**HIROSE ELECTRIC CO., LTD.**  
5-23, OSAKI 5-CHOME, SHINAGAWA-KU, TOKYO, JAPAN

**Product Change Notification**

1	Products affected	DF62W-9P-2.2DSA(01) (CL:544-1024-0-01)
2	Replacement product	DF62WZ-9P-2.2DSA(50) (CL:544-1050-0-50)
3	Classification of change	Specification change
4	Changes	The shape of the housing and housing seal will be changed. Please see the attachment for the details.  These changes will not affect the performances of the product.
5	Reason for change	To improve the resistance of housing seal detachment by wrenching.
6	Date of final reception of orders for the current product	March 29, 2019
7	Date of the first reception of orders for the replacement product	Already started selling
8	Date of final shipment of the current product	July 31, 2019
9	Date of your acknowledgement	By December 28,2018

## Shape difference①

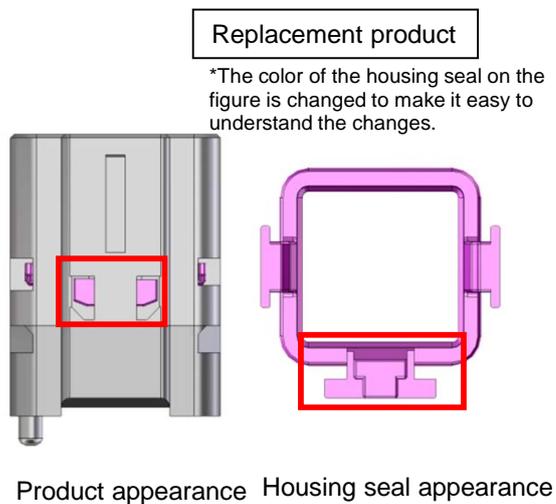
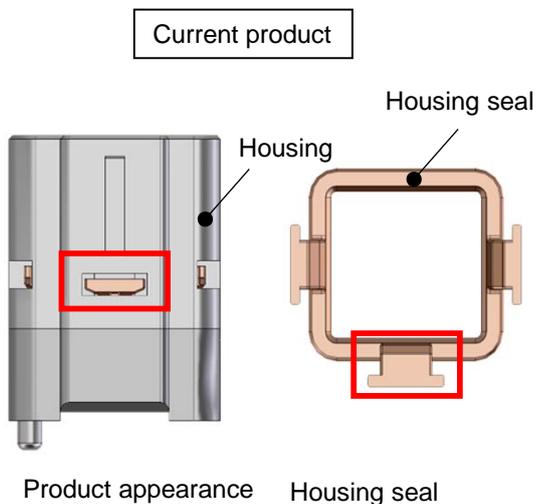
The shape of the housing seal fixing part (red frame part) is different.

## Shape difference②

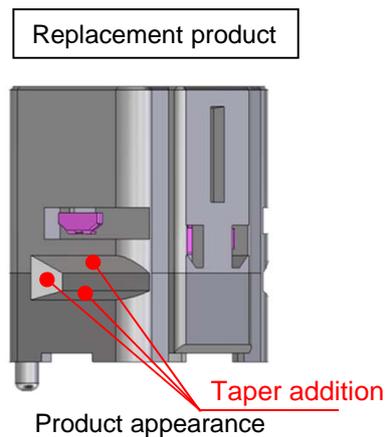
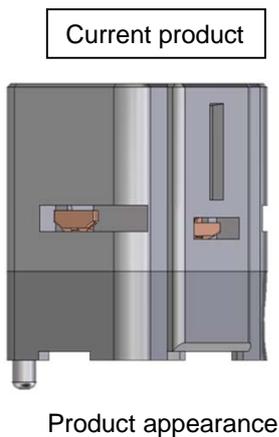
The following housing shape is different.
